A303 Amesbury to Berwick Down

Proposed Changes Consultation Booklet

July 2019

Proposed Changes Consultation Booklet – Correction Sheet

Figure 10-1 Extract from Rights of Way and Access Plans [APP-009]

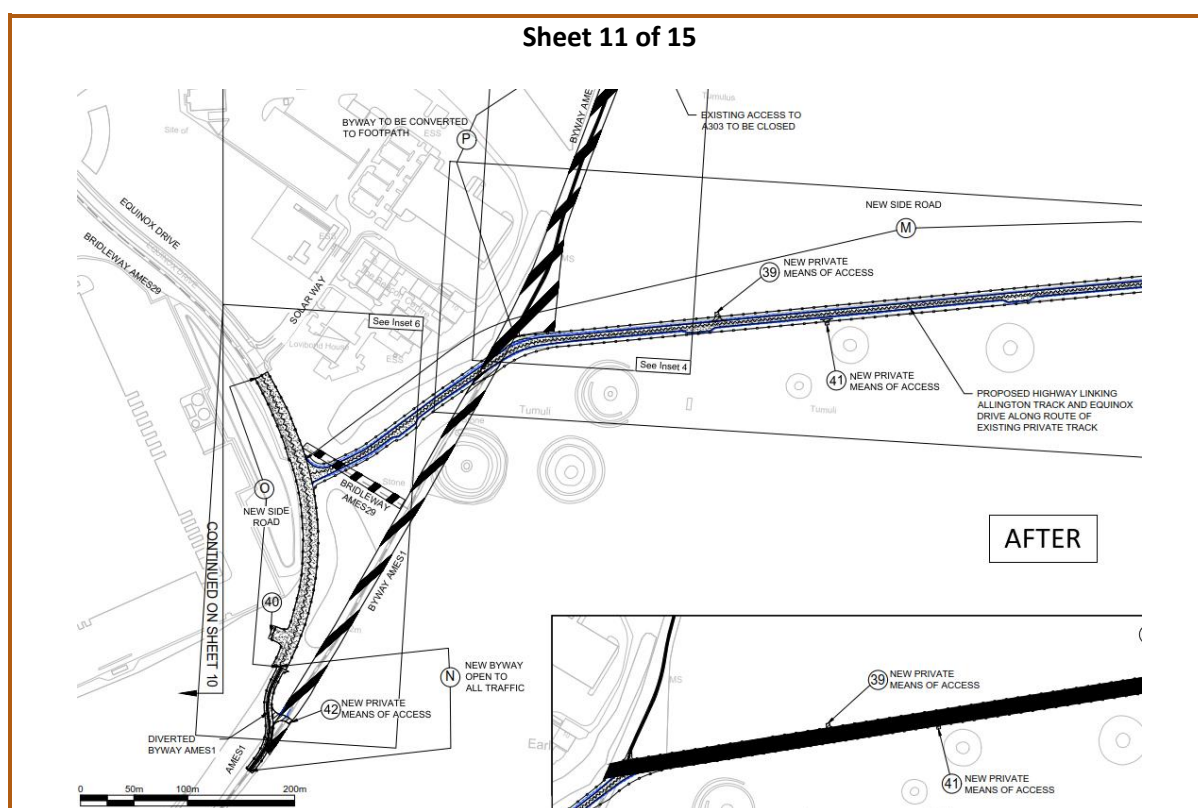
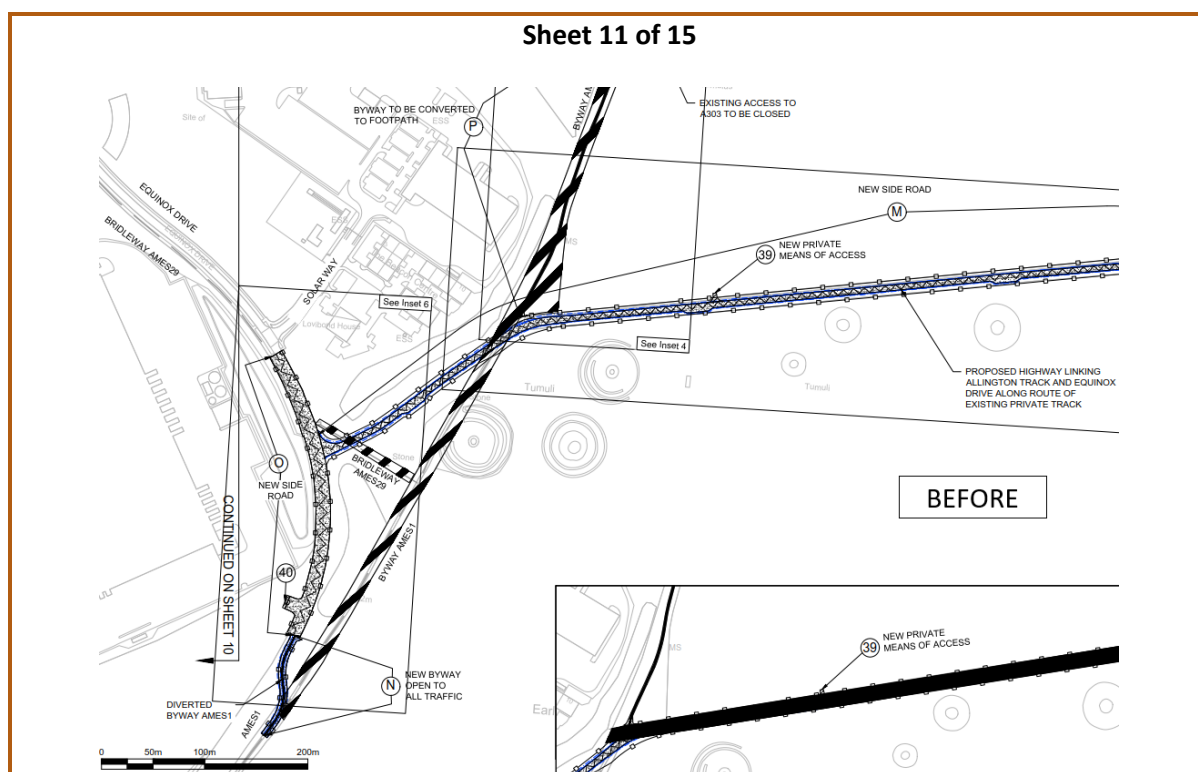
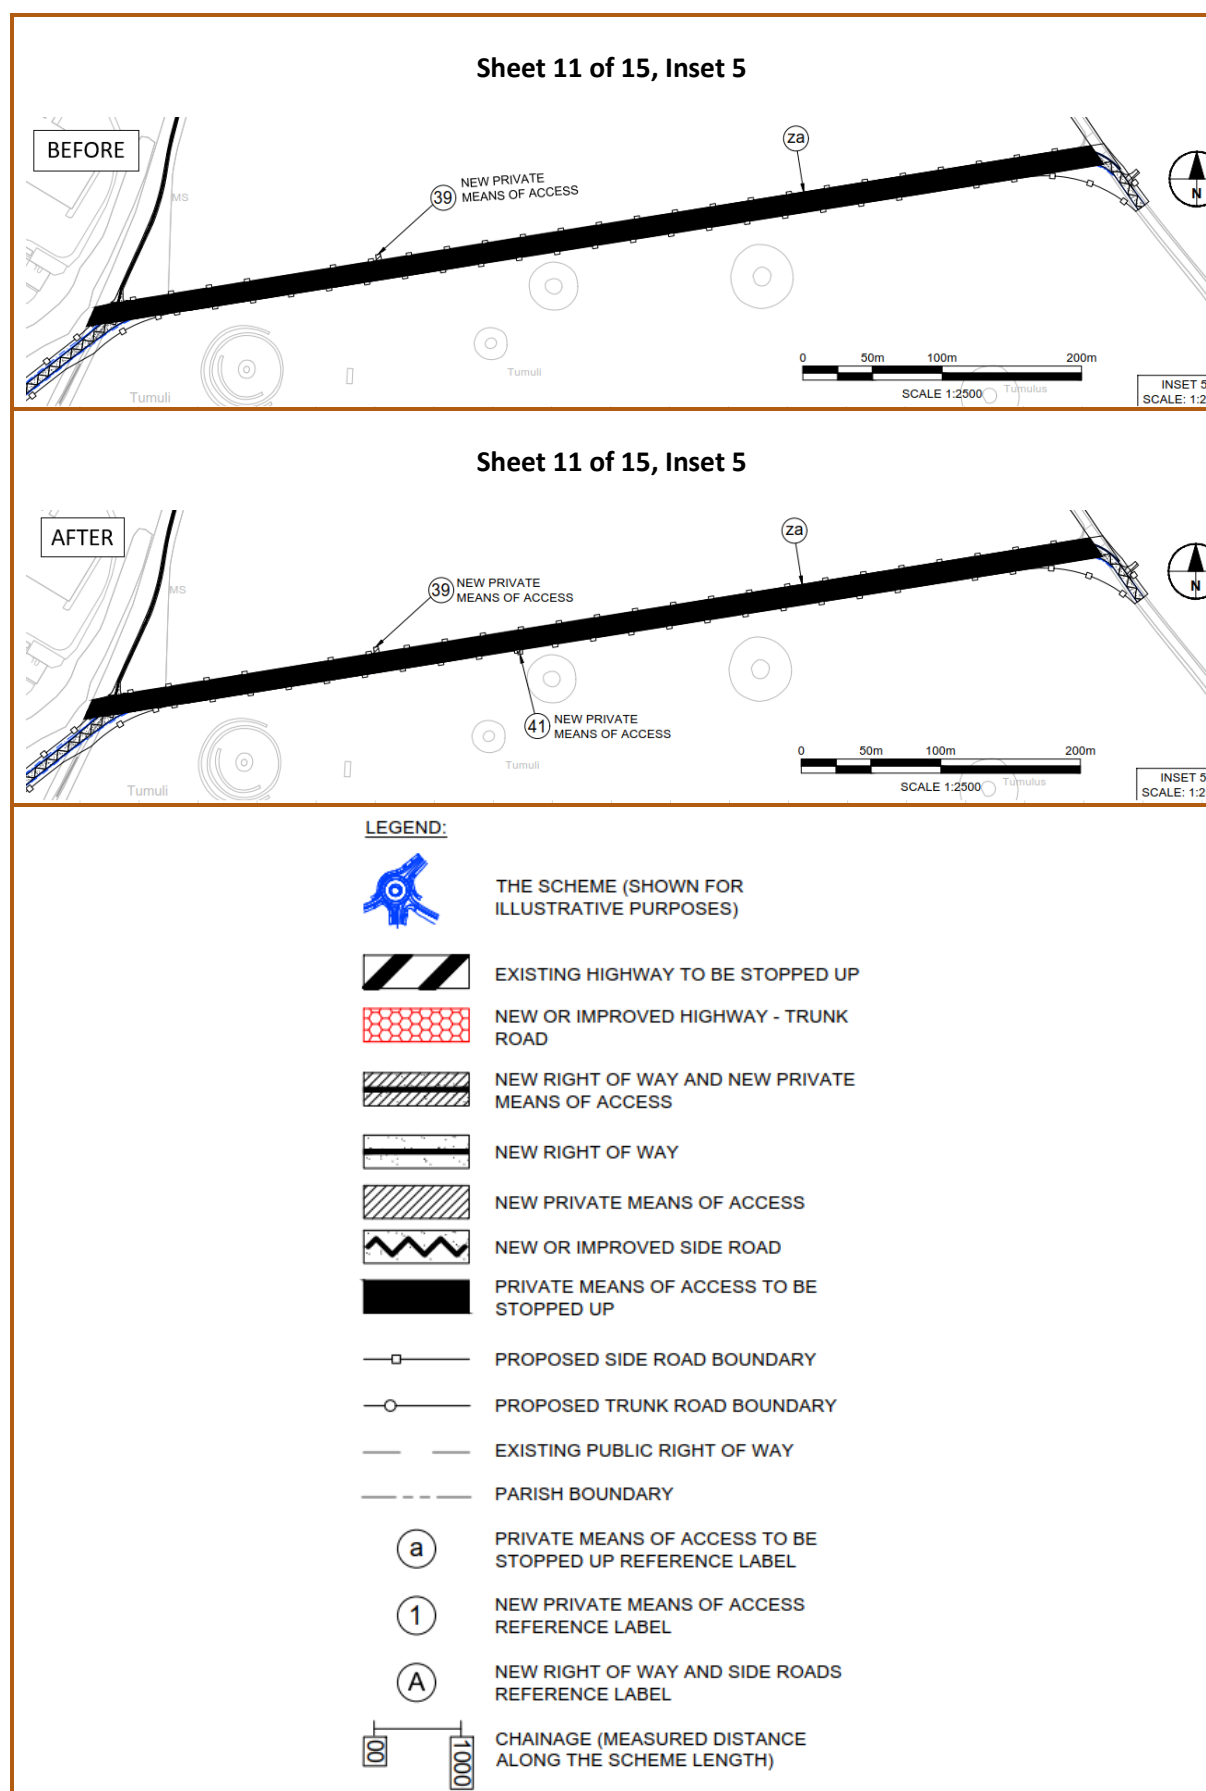
- 10.2.1 The proposed change, illustrated in Figure 10-1 below, includes a new private means of access into Earl's Farm Down from the proposed link between Allington Track and Equinox Drive, and from the proposed link between Equinox Drive and Amesbury Road.

- 10.2.2 The proposed change would need to be added to the Rights of Way and Access Plans (Sheet 11 of 15, including Inset 5 on that Sheet) [APP-009] as new PMA Reference 41 and new PMA Reference 42 with corresponding entries also being added to Part 3 of Schedule 3 to the draft Development Consent Order.

Figure 11-1 Extract from Rights of Way and Access Plans [APP-009]

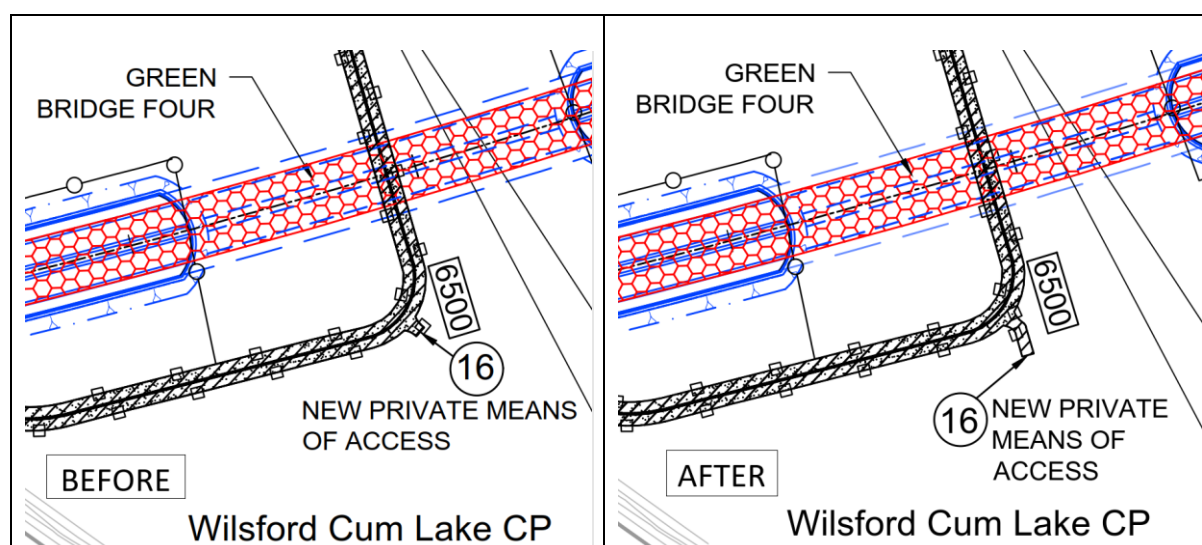
11.2.1 As shown in Figure 11-1 below, the proposed change includes an extension to PMA16 (which is already shown on Sheet 5 of the Rights of Way and Access Plans) from the south side of the new restricted byway south of Green Bridge No.4.

11.2.2 The proposed change would need to be added to the Rights of Way and Access Plans (Sheet 5 of 15) [APP-009]. No amendment would be required to the corresponding drafting in Part 3 of Schedule 3 to the draft DCO.
